Docket Item # 12 A-C

Planning Commission

October 2, 2007

Docket Item #12 A-C
DEVELOPMENT SPECIAL USE PERMIT
2006-0031- GLEBE PARK – OLD DOMINION EAST
2006-0030 - GLEBE PARK – WEST GLEBE
SPECIAL USE PERMIT
#2007-0006 - GLEBE PARK - OLD DOMINION WEST

Fig. 22: WEST GLEBE – Proposed Site Plan

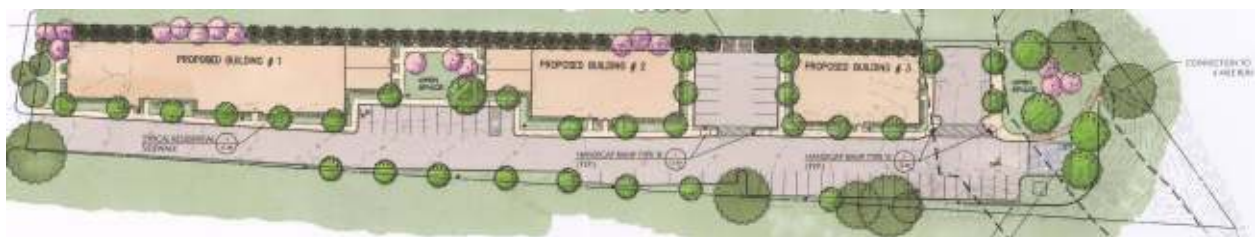
The proposal is to replace the existing 56 ARHA units with 48 new apartments. The new apartments will be located in three separate buildings, with 24, 14 and 10 units respectively. Four townhouse style units are located in the center of the site, surrounding the interior open space courtyard.

Fig. 28: WEST GLEBE – Staff Recommended Parking & Open Space Design

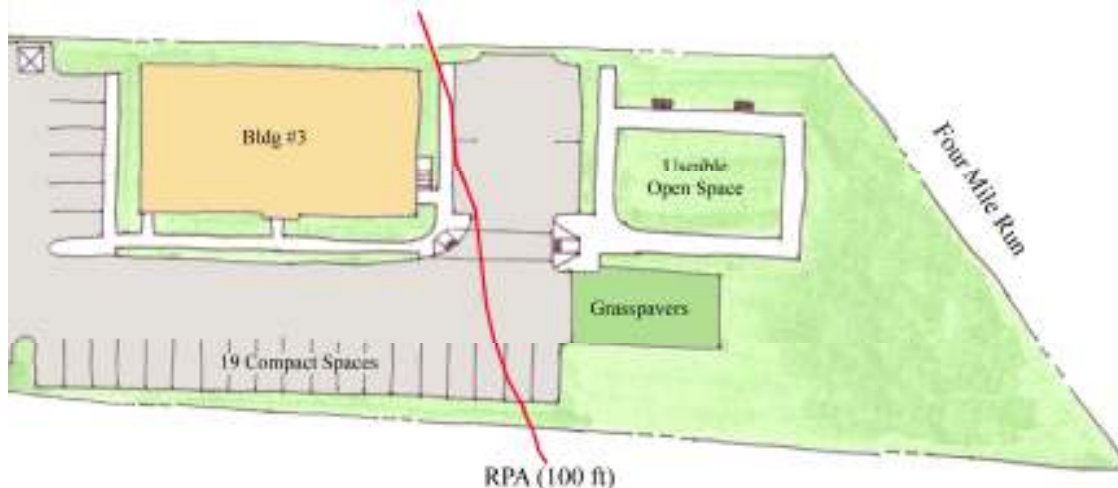
Staff has worked with the applicant to provide as much green space and buffer as possible next to Four Mile Run to ensure the future greenway and trail could be completed as part of future redevelopment of the adjoining sites. Staff has also recommended a public access easement for the area adjacent to Four Mile Run to ensure the potential future use of this property. The applicant has worked with staff to push the building farther away from Four Mile Run however there is still a considerable amount of parking proposed within the Resource Protection Area. Therefore, staff is recommending eliminating some parking spaces from the area adjacent to Four Mile Run to provide additional on-site open space, reduce the size of the proposed retaining wall, and provide a large buffer next to the stream.

The staff recommendation would result in the loss of parking spaces but would provide the additional open space, which staff believes can be justified by the parking study for the public housing units. The recommendation is an attempt to balance the parking demands and the vision of the Four Mile Run Master Plan and bring the proposal into greater compliance with the amount of open space required by the Zoning Ordinance.
